AMENDMENT TO APPLICATION
SOUTH TREND DEVELOPMENT AREA
DISCHARGE PLAN APPLICATION

SOUTH TREND DEVELOPMENT AREA APPLICATION
IN SITU PROJECT
McKINLEY COUNTY, NEW MEXICO

Errata/Minor Changes

Figure B 1.5.5-1 REGIONAL SOIL MAP for the SOUTH TREND DEVELOPMENT AREA
(from MAKER et al, 1974)

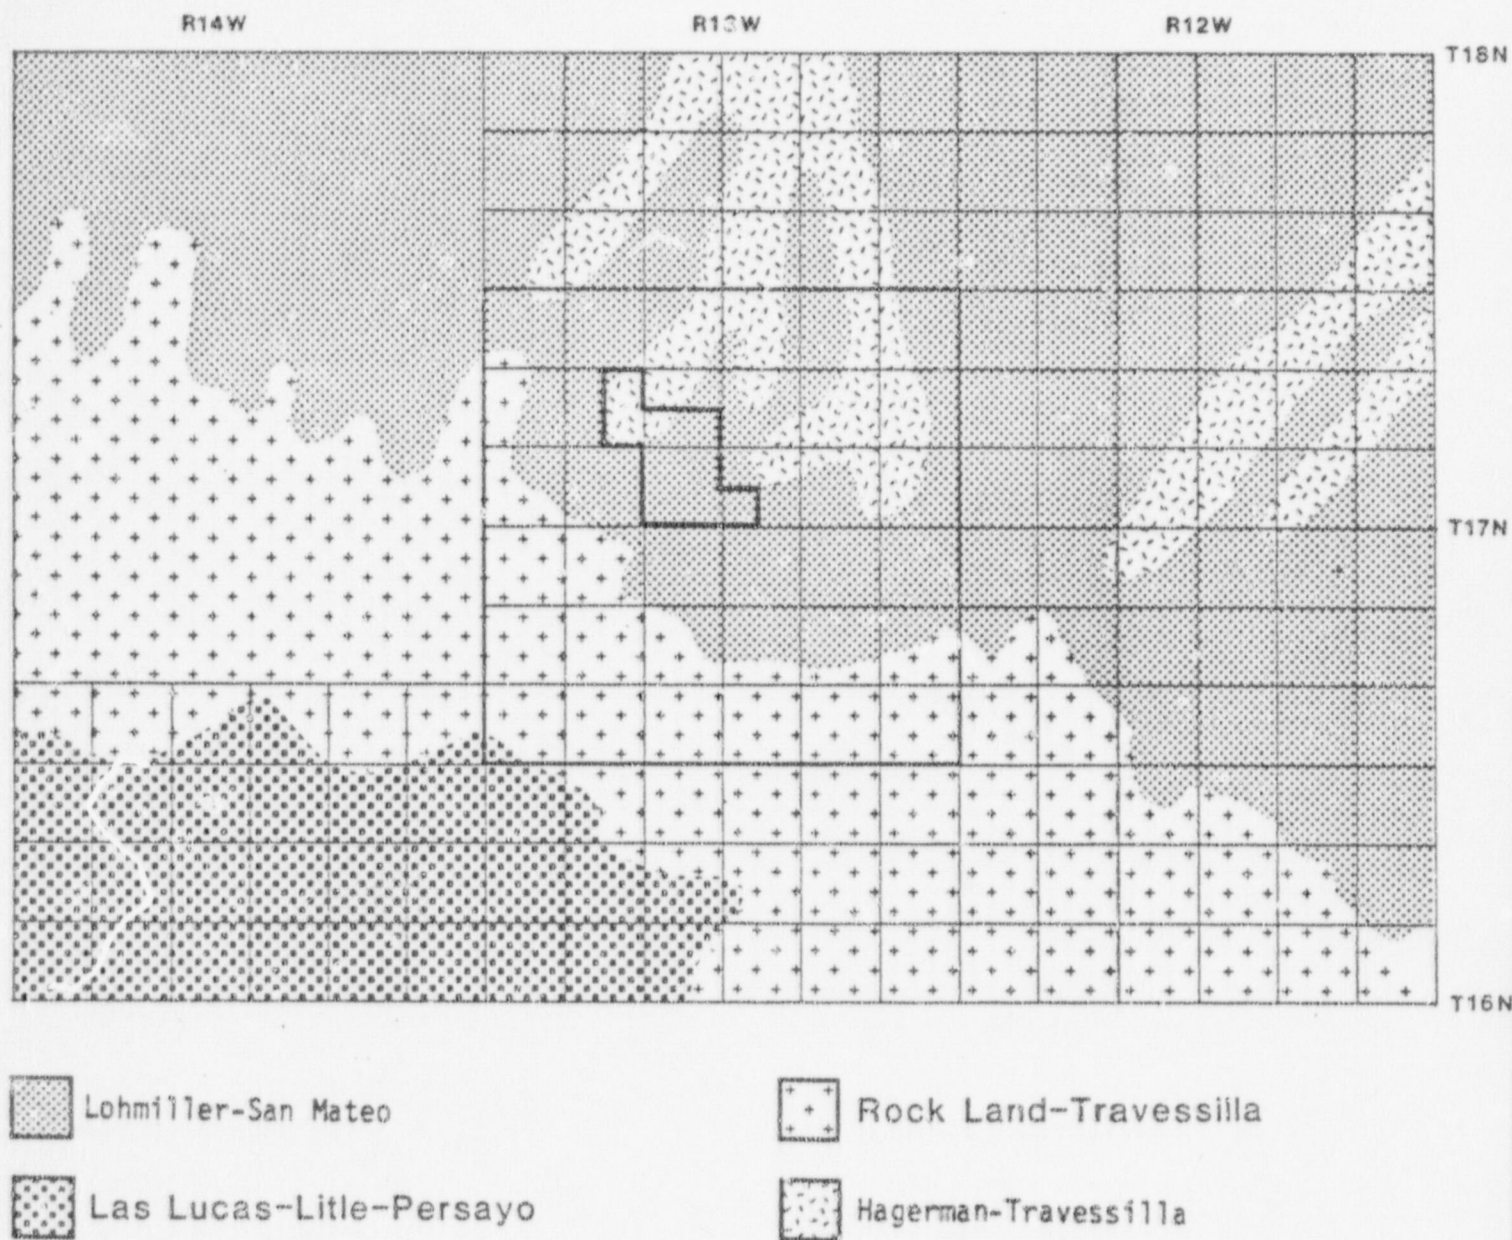
1. All references to "evaporation pond(s)" or "evaporation (waste) pond(s)" should read "operating and evaporation pond(s)."
2. P. B-102 Figure B 1.5.5-1
The names of the soil associations "Hagerman-Travessilla" and "Lohmiller-San Mateo" should be reversed to match the map and text.
3. P. B-137 Last line on the page
Radon-227 should be changed to Radon-222
4. P. B-195 Section 3.5.1. Vegetation - (the following section will replace the section in the report).
